Regulation No. 46 (Devices for indirect vision)

Proposal for a draft Supplement to the 04 series of amendments to Regulation No. 46 (Devices for indirect vision)

Submitted by the expert from the Netherlands^{*}

Figure 7

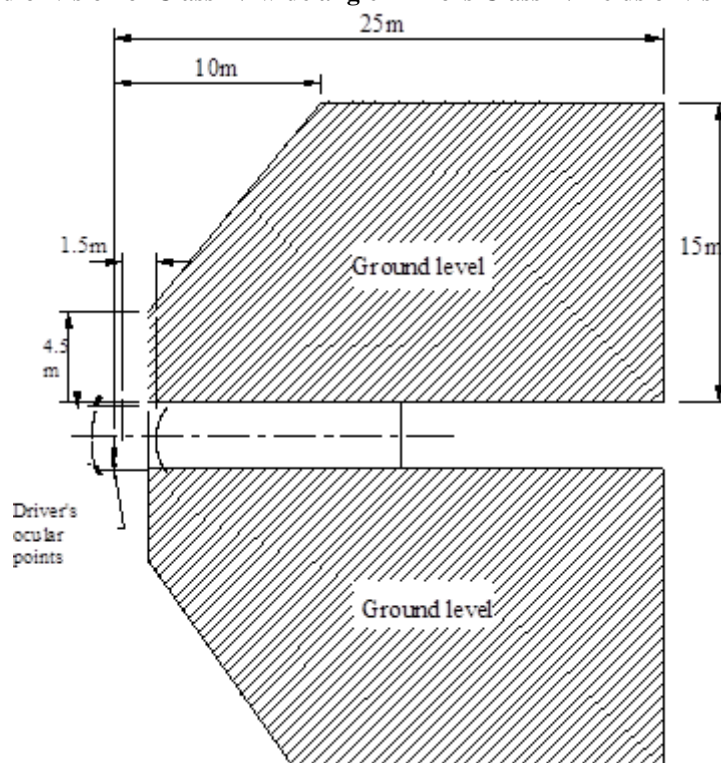
Figure 7 has been corrected on the passenger's side so that the indicated dimensions are in correspondence with the front of the grey area.
